July 22, 3013

**Re: Response to EPA Completeness Comments
Occidental Chemical Corp
Ingleside Chemical Plant
Ethylene Plant GHG PSD Permit Application**

Response to EPA Completeness Comments
Occidental Chemical Corporation
Application for Greenhouse Gas Prevention of Significant Deterioration Permit
Ingleside Chemical Plant – Ethylene Plant

Occidental Chemical Corporation
 Ethane Cracking Facilities
 Process Flow Diagram
 Ingleside, Texas
 Page 1 of 3
 Originator: MRE Date: 10/8/12
 Revision 1 by: MRE Date: 7/17/13

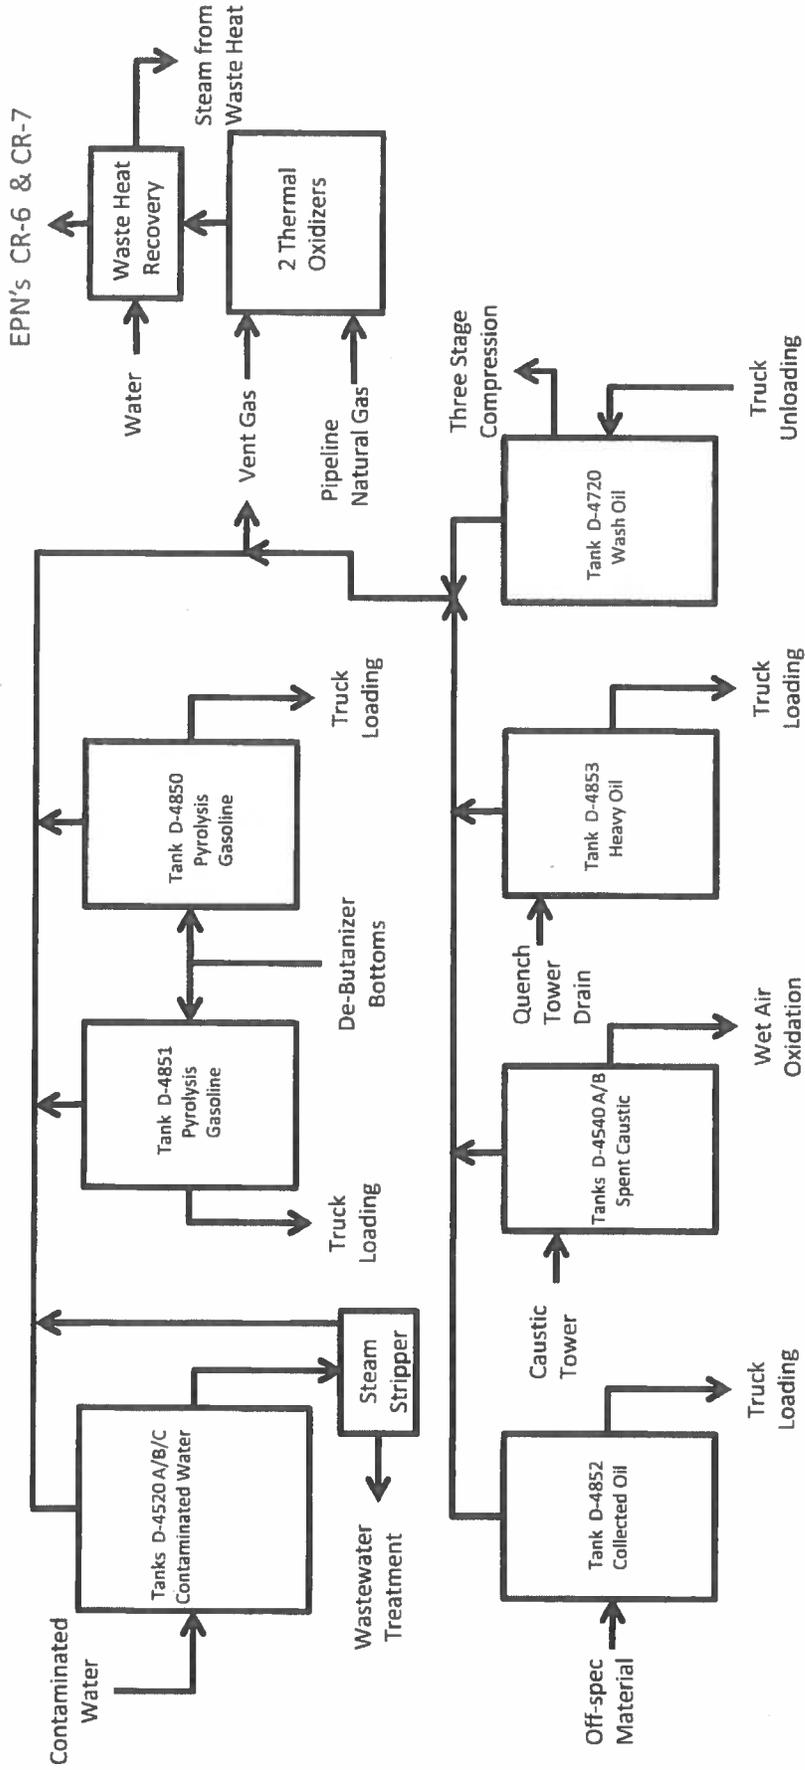
- A. On page 2 of the permit application, it states that recycle ethane from the Ethylene Fractionator is combined with ethane feed and superheated with water before being sent to the cracking furnaces. Please show this combining of streams on the process flow diagram.

Response: See attached Revision 1 Process Flow Diagram
 - B. The permit application indicates the use of selective catalytic reduction (SCR) technology for NO_x control. Please indicate this add-on pollution device on all five of the cracking furnaces.

Response: See attached Revision 1 Process Flow Diagram
 - C. The permit application states that to reduce coke formation in the cracking furnace tubes, a sulfide material is added continuously to the ethane feed. This sulfide chemical is stored in a pressurized tank. Please show this chemical addition in combination with the ethane feed.

- E. It is stated in the permit application that the condensed gasoline and dilution steam, along with quench water, are separated in the bottom section of the Quench Tower and the non-condensable gas exits the top of the quench column. It is also stated that the Quench Tower overhead vapor is sent to the first stage of the steam driven-charge gas compressor. Is the "non-condensable gas that exits the top of the Quench Column" the same stream that is referred to as the "Quench Tower overhead vapor"? Are these two different streams? Please explain and if appropriate, revise the process flow diagram to properly show these streams and where the streams are directed.

- F. The permit application states that the charge gas from the dryer feed chiller system overhead is dried in a molecular sieve drying system before entering the De-Ethanizer. Please update the process flow diagram to show the molecular sieve system.

- G. The permit application states that the De-Ethanizer overhead product is chilled and sent to the De-Methanizer. Please supplement the process flow diagram to show the heat exchanger used to chill the overhead product from the De-Ethanizer.

- H. The permit application states that the De-Methanizer bottoms are fed to the Ethylene Fractionator. Is the Ethylene Fractionator represented on the process flow diagram as the C2 Splitter? Are the names used interchangeably? If so, please include Ethylene Fractionator as an alternate name for the C2 Splitter on the process flow diagram. If the Ethylene Fractionator is a different unit, please include on the process flow diagram.

- I. On page 3 of the permit application, a summary of the storage tanks that are proposed for this project is provided. Please include a depiction of these storage tanks on the process flow diagram. Also, include the Wastewater Storage Tank and Steam Stripper.

Response: The attached Revision 1 of the Process flow diagram has been revised to use the term Ethylene Fractionator.

Response: See attached Revision 1 Process Flow Diagram

Occidental Chemical Corporation
Ethane Cracking Facilities
Process Flow Diagram
Ingleside, Texas

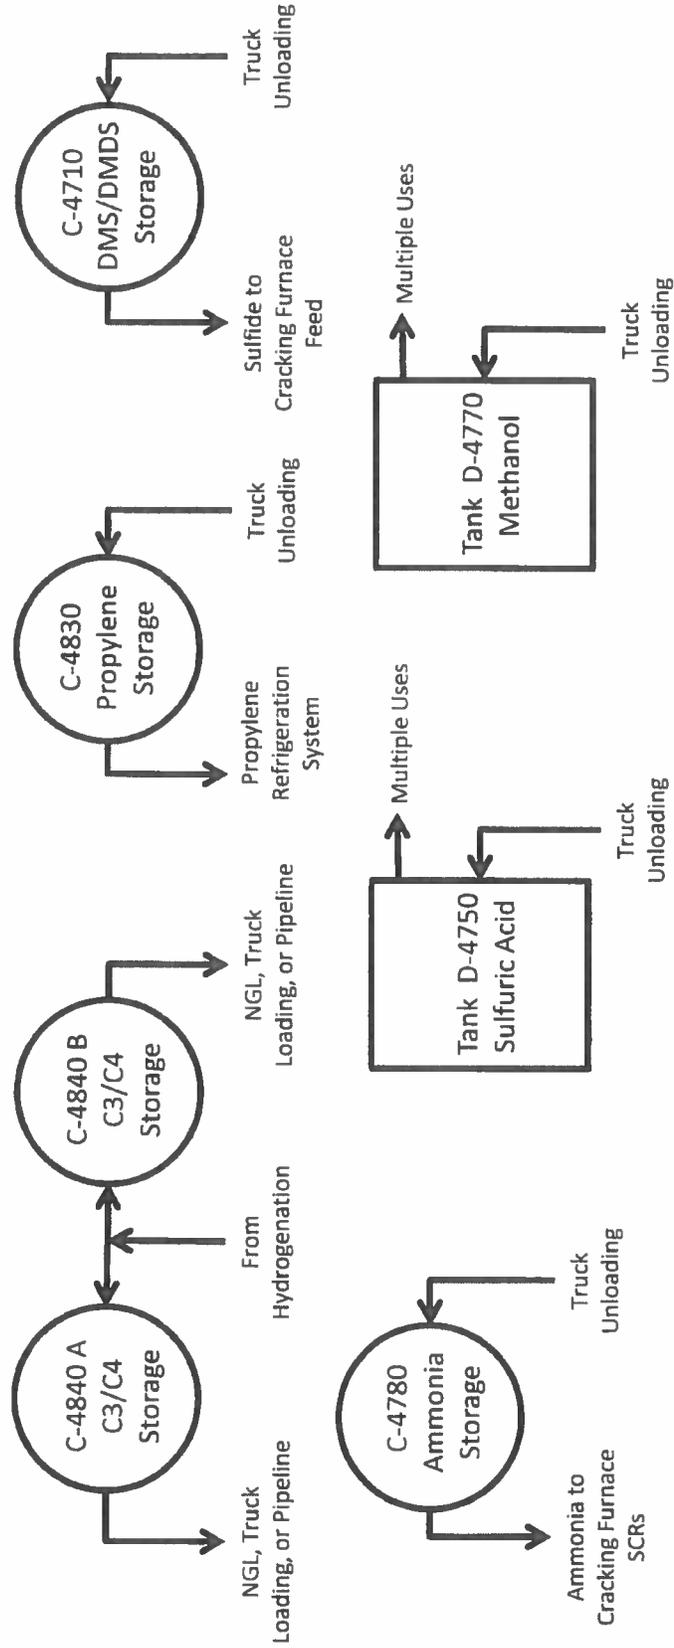
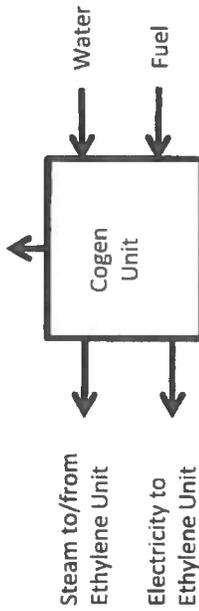
- K. On page 10 of the permit application, it states that the existing cogeneration units are not being modified and their increased fuel firing will not exceed previously authorized levels. However, as affected sources the cogenerations units will enter the scope of the project to supply the new demand for steam and power for the proposed facilities. Please supplement the process flow diagram to show these affected (existing non-modified emission points where emissions will increase) units along with the appropriate EPNs and identify this units as affected.

Response: See attached Revision 1 Process Flow Diagram

EPN CR-13, CR-14, CR-15,
CR-16, *CR-17, *CR-18

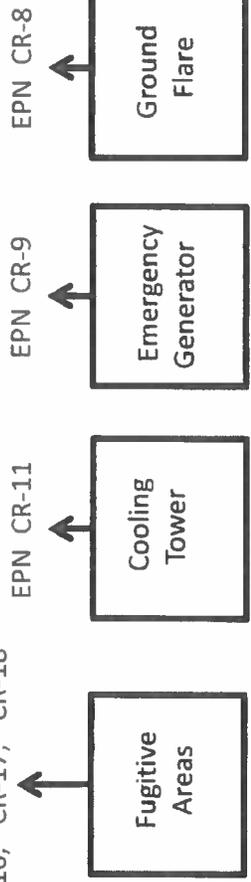
- J. On page 9 of the permit application, it is stated that fugitive emissions were estimated for six areas of the proposed facilities: CR Furnace Area Fugitives (EPN: CR-13), CR Charge Gas Area Fugitives (EPN: CR-14), CR Recovery Area Fugitives (EPN: CR-15), CR C3+ Area Fugitives (EPN:CR-16), CR Waste Treatment and C5 Area Fugitives (EPN: CR-17) and CR LPG Storage Area Fugitives (EPN: CR-18). However, since the last two areas do not contain GHG pollutants, they are not included in this GHG application. The current process flow diagram shows all six emission units. Please supplement the process flow diagram to indicate that the emission units EPN: CR-17 and EPN: CR-18 are non-GHG sources.

Response: See attached Revision 1 Process Flow Diagram
